Technical Bulletin 178

G4 FLASH issue pertaining to external multivariable (XMV) calibrations

Version 1.0 Revision AC (11 November 2009)

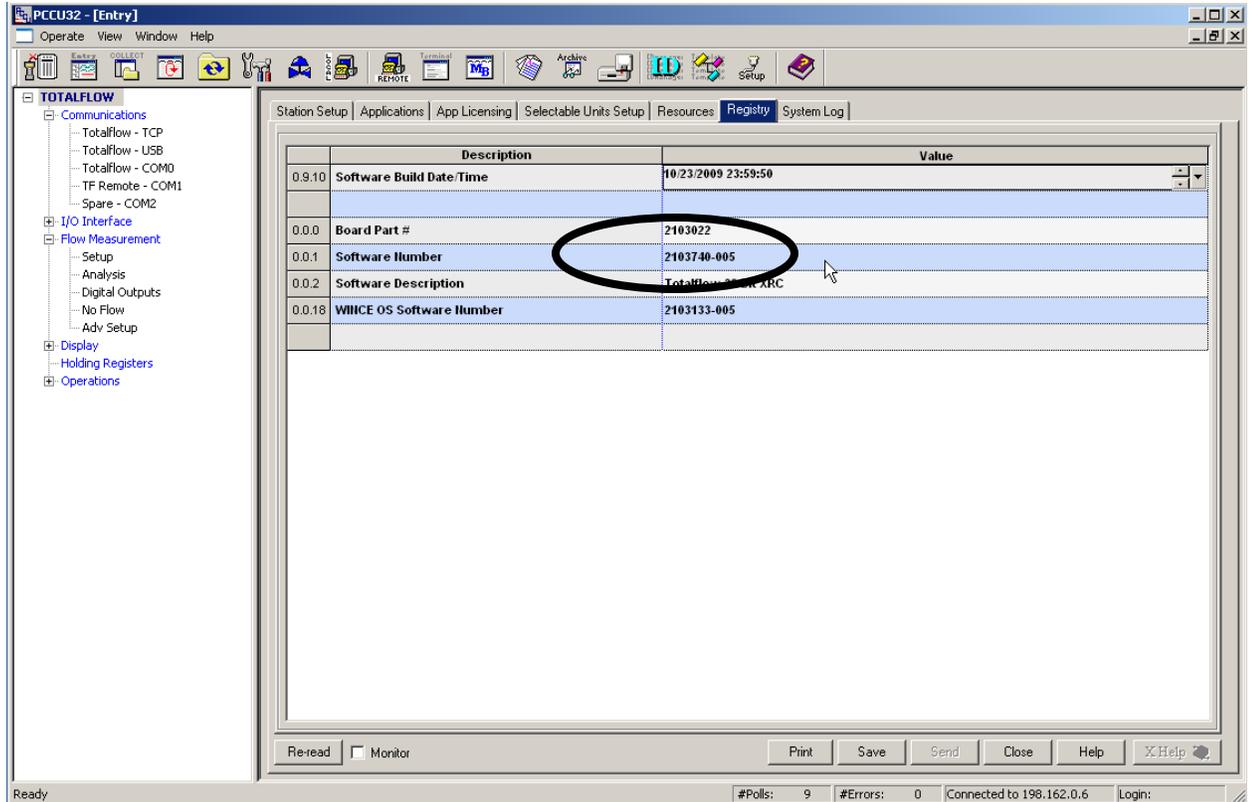
1. Connect to the device
2. Go into entry mode
3. Select "registry" tab
4. Verify the "software number" matches one of the above listed part numbers (see picture below for details).

Replace the existing FLASH with the previous revision FLASH (i.e. 2102861-018 or earlier) or contact Totalflow service for the latest version that has this issue corrected. Totalflow anticipates the new FLASH images to be available for distribution on 11/16/2009.
